PLANT NAME: NINE MILE POINT UNIT #1

ENCLOSURES:
Info re postulated pipe failure outside containment structure for Nine Mile Point Unit #1

Re: Nine Mile Point Unit 1
Docket No. 50-220

Your letter of January 29, 1974 requested additional information concerning high energy line breaks outside the containment for Nine Mile Point Unit 1. The additional information is attached in the form of responses to the specific questions included in your letter.

FIGURE 2-1

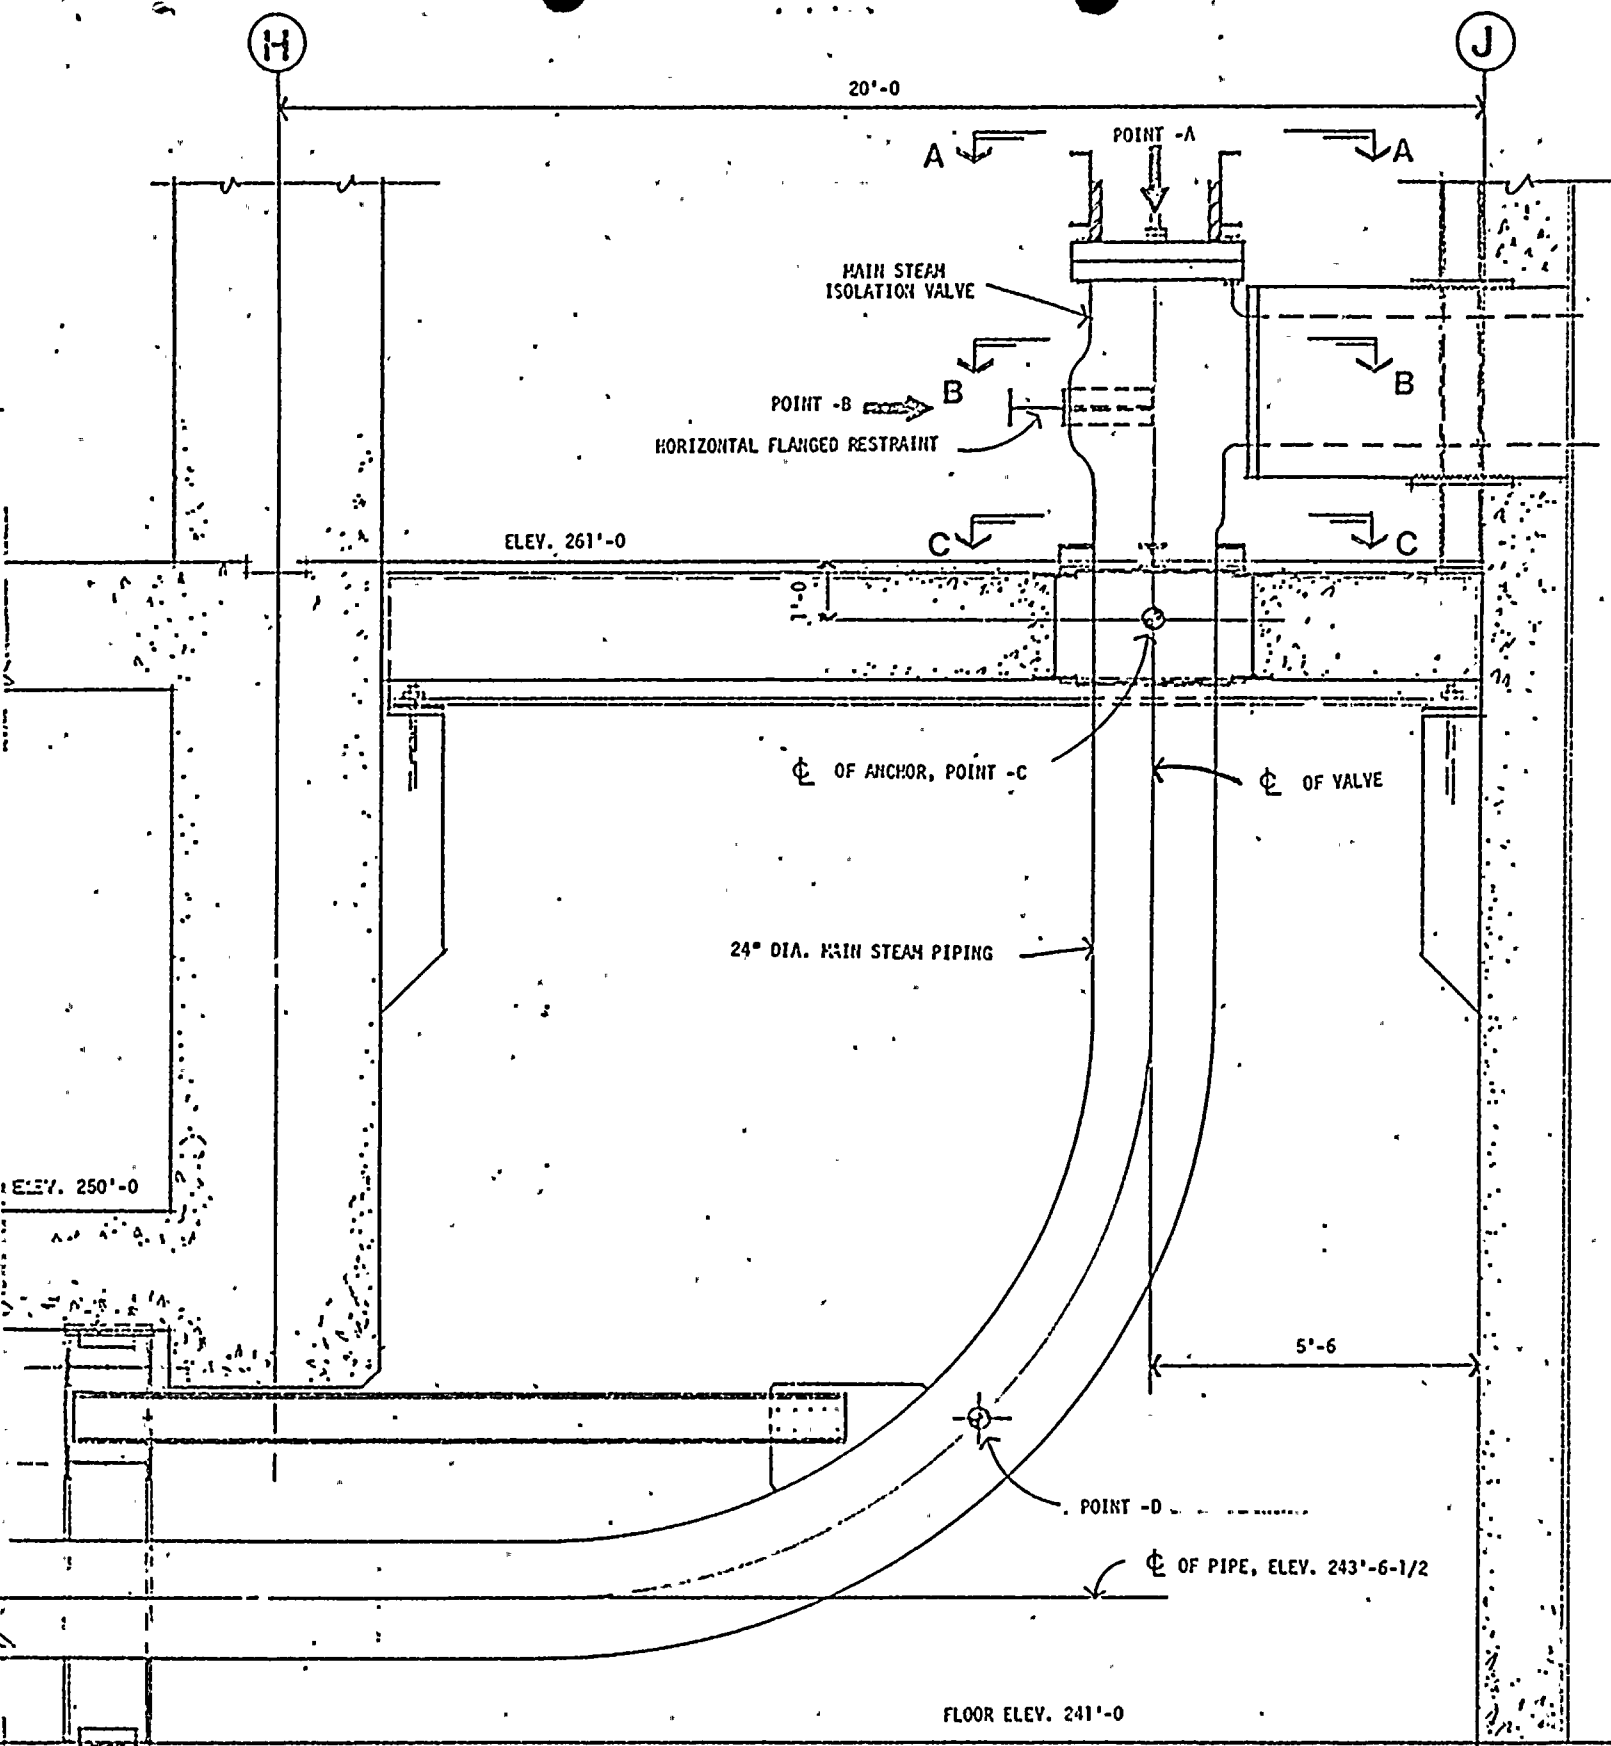
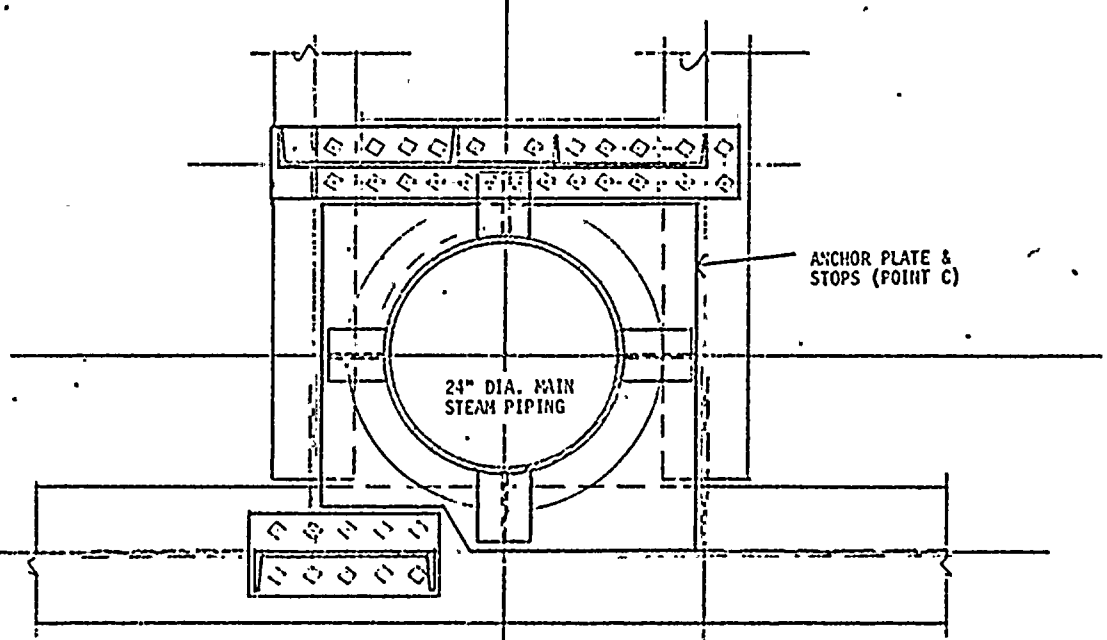
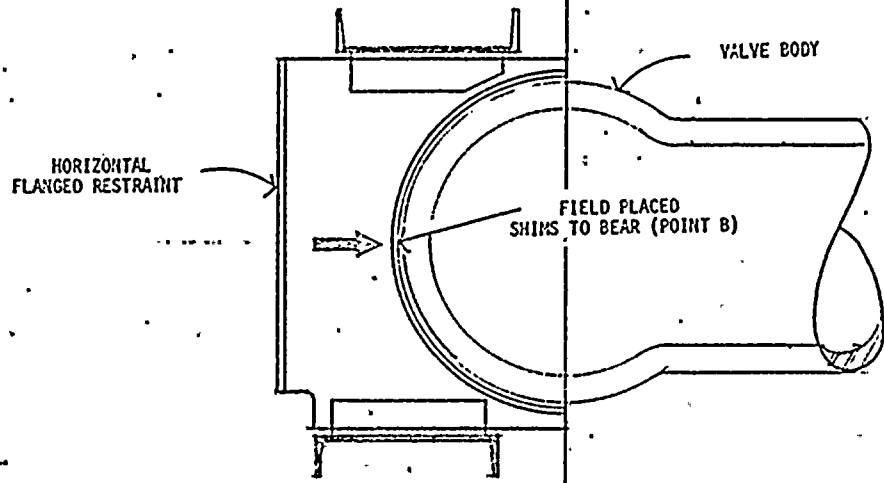
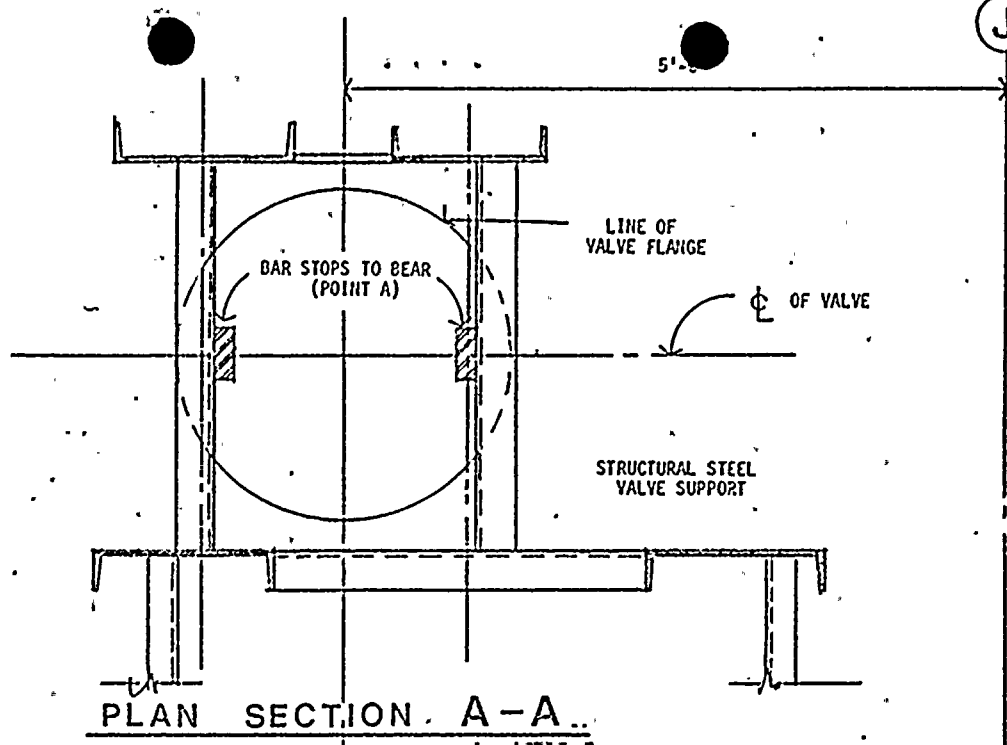
Describe the anchors at the main steam line isolation valves and/or the seismic restraints designed as pipe whipping restraints.

The main steam isolation valves are supported as shown in Figures 2-1 and 2-2. Points A, B and D are designed to resist a guillotine break in the main steam line on either side of the valve. The design force for this pipe break is 240 kips. Point C is an anchor point for thermal and seismic forces.

Figure 3-1

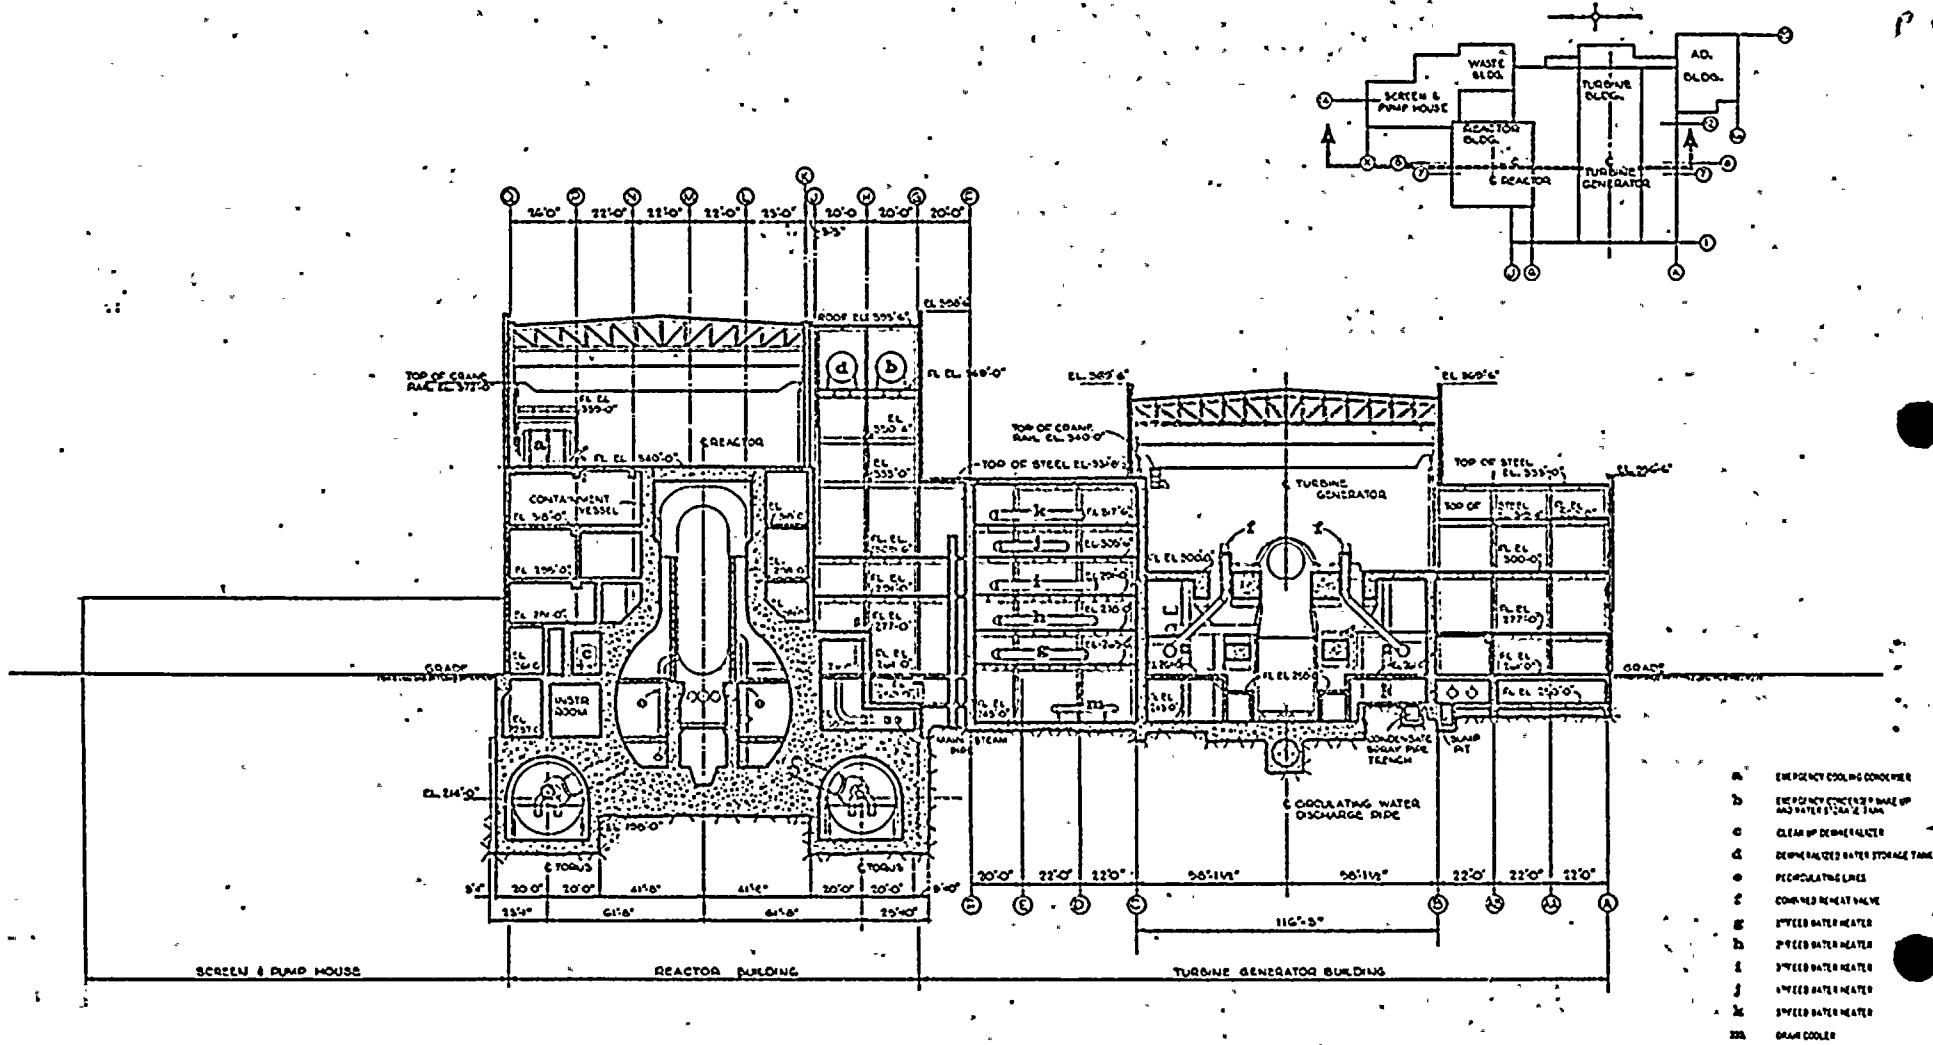
Describe the reactor cleanup system pipeline run as related in proximity to the torus. Provide necessary plan and elevation drawings showing its routing. Indicate whether a rupture of this pipeline could cause damage to the torus.

As described in our June 29, 1973 submittal on pages 17 and 18 and Figure 3, no portion of the reactor cleanup system piping which is classified as high energy goes below elevation 261 feet.

Figure 3-1 of this submittal shows a plan of the station. The area in which the cleanup system is located is denoted by "C" on the figure (elevation 261 feet, columns N - Q). As can be seen, there are two separate concrete floors between any of the high energy reactor cleanup system piping and the suppression chamber. However, there is a relief valve discharge line to the chamber. This line is not high energy since it is designed for 150 PSIG and 120 F. It has been concluded that no damage to the chamber could be effected by a rupture in the cleanup system.
